SERVICE BULLETIN

1340 CLUTCH INFORMATION FOR 1990 MODELS

M-991

Figure 1. Clutch Release Components

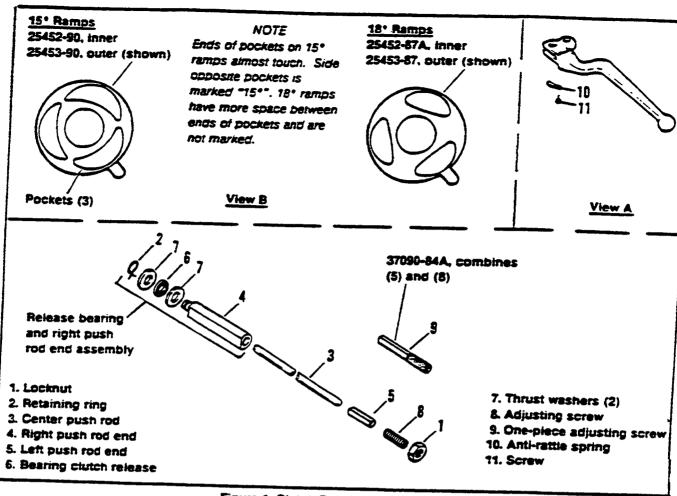
See Figure 1. The left push rod end, Part No. 37090-84 and adjusting screw, Part No. 37357-84 have been replaced by a single item Part No. 37090-84A. This change reduces the possibility of clutch drag by decreasing any tendency for the clutch pressure plate to tip. This change was made to production vehicles in December, 1989.

See Figure 1, View B. Beginning March 28, 1990, transmission number 90087042, clutch release ramps, Part No. 25452-87A (inner) and 25453-87 (outer) will be used in production. These ramps will provide more movement (lift) to the push rod to further reduce the possibility of clutch drag. This change will stightly increase clutch lever effort.

See Figure 1, View A. During the installation of the one-piece adjusting screw and earlier release ramps, remove the anti-rattle spring (10) and its' retaining screw (11). The spring may affect free-play in the clutch lever and could cause the clutch throw-out bearing to be slightly loaded. That loading could cause premature tailure of the throw-out bearing.

- 3. See Figure 1. With a magnet, remove the left push rod end (1).
- Install new one-piece adjusting screw into release plate and install locknut (2) on adjusting screw. DO NOT ADJUST PUSH ROD NOW, adjust after release ramps have been installed.

- Refer to pages 7-30 and 7-31 in the 1985 TO 1990 FX/SOFTAIL MODELS Service Manual, Part No. 99482-90 for instruction on removing release ramps and installing the earlier ramps. See Figure 1, View B for identification of release ramps.
- 2. See Figure 1. After transmission side cover has been removed, remove the clutch release bearing and push rod assembly and center push rod (3). Install a new release bearing if excessive wear or overheating of bearing is evident. Also inspect the center push rod (3) for wear or damage, Install new push rod parts if required.

Figure 2. Push Rod Adjustment

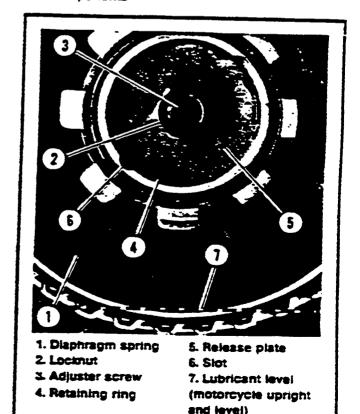
- Loosen clutch cable and remove the clutch inspection cover.
- 2. See Figure 2. Loosen locknut (2) and unthread adjuster screw (3) from release plate (5).

3. See Figure 2. After transmission side cover has been installed, fill the transmission with lubricant to the full mark on dipstick with dipstick resting in place (not threaded into side cover). Adjust clutch push rod by lightly bottoming adjuster screw (3) and then backing screw out 1/2 - 3-4 turn. Hold screw with allen wrench and tighten locknut (2) to 6-10 ft-lbs torque.

Adjust clutch cable free play at the clutch lever to 1/8-3/16 in. The same free play specification was used on 1989 models.
